# Access Compliance Report

## Public Rights-of-Way

### (Pedestrian Signals)

Intersection ID: N/A	Main Street:	Cross Street: N/A	Location: N/A
ADA ID: 8F65C888C8D8	Signal Type: One Push Button-Non APS	Overall Compliance: No	Severity Score: BTN 1: N/A BTN 2: N/A No BTN: N/A
Codes/Mitigation Info/Possible Solution		Field Measurements/Component Compliance

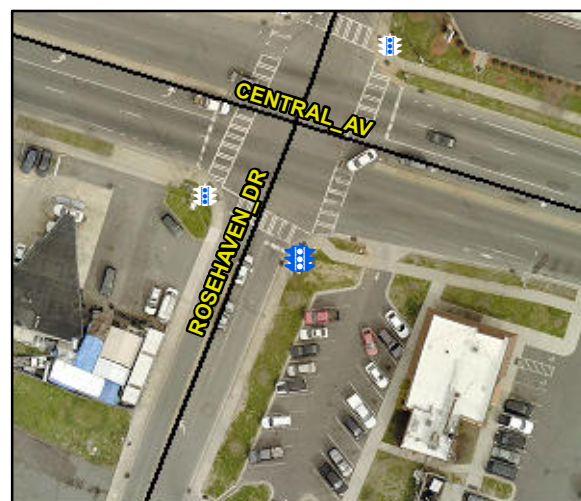
Surveyor Notes: TEXT HT 1/2

Compliance	Description	Data	Compliance	Description	Data
	Button Count	Button1	N/A	Distant to Additional Button (in)	N/A
	Additional Button Present?	No		Additional Button ID	N/A
N/A	Signal Buttons Required?	N/A	N/A	Additional Ped Posts Required	N/A
	How Many Ped Street Xings?	2		Located In An Island/Median?	No
N/A	B 1 Sign Present?	Yes	N/A	B 2 Sign Present?	N/A
Yes	B 1 Sign Purpose?	Yes	N/A	B 2 Sign Purpose?	N/A
No	B 1 Sign Lettering & Contrast?	No	N/A	B 2 Sign Lettering & Contrast?	N/A
No	B 1 Parallel To XWalk?	No	N/A	B 2 Parallel To XWalk?	N/A
Yes	B 1 PAR to Button?	Yes	N/A	B 2 PAR to Button?	N/A
Yes	B 1 PAR to XWalk?	Yes	N/A	B 2 PAR to XWalk?	N/A
Yes	B 1 Clear Floor Space?	Yes	N/A	B 2 Clear Floor Space?	N/A
N/A	B 1 FWD Approach?	Yes	N/A	B 2 FWD Approach?	N/A
N/A	B 1 FWD Approach Constrained?	No	N/A	B 2 FWD Approach Constrained?	N/A
No	B 1 FWD Approach Reach (in)	12.0	N/A	B 2 FWD Approach Reach (in)	N/A

N/A	B 1 FWD Approach Width (in)	N/A	N/A	B 2 FWD Approach Width (in)	N/A
N/A	B 1 FWD Approach Obstruction?	Yes	N/A	B 2 FWD Approach Obstruction?	N/A
N/A	B 1 FWD Approach Obstruction Dist (in)	3.5	N/A	B 2 FWD Approach ObstructionDist (in)	N/A
N/A	B 1 PARA Approach?	Yes	N/A	B 2 PARA Approach?	N/A
N/A	B 1 PARA Approach Constrained?	No	N/A	B 2 PARA Approach Constrained?	N/A
No	B 1 PARA Approach Reach (in)	12.0	N/A	B 2 PARA Approach Reach (in)	N/A
N/A	B 1 PARA Approach Width (in)	N/A	N/A	B 2 PARA Approach Width (in)	N/A
N/A	B 1 PARA Approach Obstruction?	Yes	N/A	B 2 PARA Approach Obstruction?	N/A
N/A	B 1 PARA Approach Obstruction Dist (in)	3.5	N/A	B 2 PARA Approach ObstructionDist (in)	N/A
No	B 1 Clear Floor Space Slope (%)	4.0	N/A	B 2 Clear Floor Space Slope (%)	N/A
No	B 1 Clear Floor Space XSlope (%)	3.5	N/A	B 2 Clear Floor Space XSlope (%)	N/A
N/A	B 1 PAR Slope (%)	2.2	N/A	B 2 PAR Slope (%)	N/A
Yes	B 1 Height (in)	36.0	N/A	B 2 Height (in)	N/A

Yes	B 1 Clear Xing Direction?	ClearlyMarked	N/A	B 2 Clear Xing Direction?	N/A
	B 1 Crossing Direction	To N		B 2 Crossing Direction	N/A
Yes	B 1 DistanceTo XWalk (in)	0.0	N/A	B 2 DistanceTo XWalk (in)	N/A
No	B 1 DistanceTo Curb (in)	94.0	N/A	B 2 DistanceTo Curb (in)	N/A
Yes	B 1 Diameter (in)	2.0	N/A	B 2 Diameter (in)	N/A

Possible Solutions: Replace Signal Push Button With APS Button on New Post. Remove & Replace Sign.
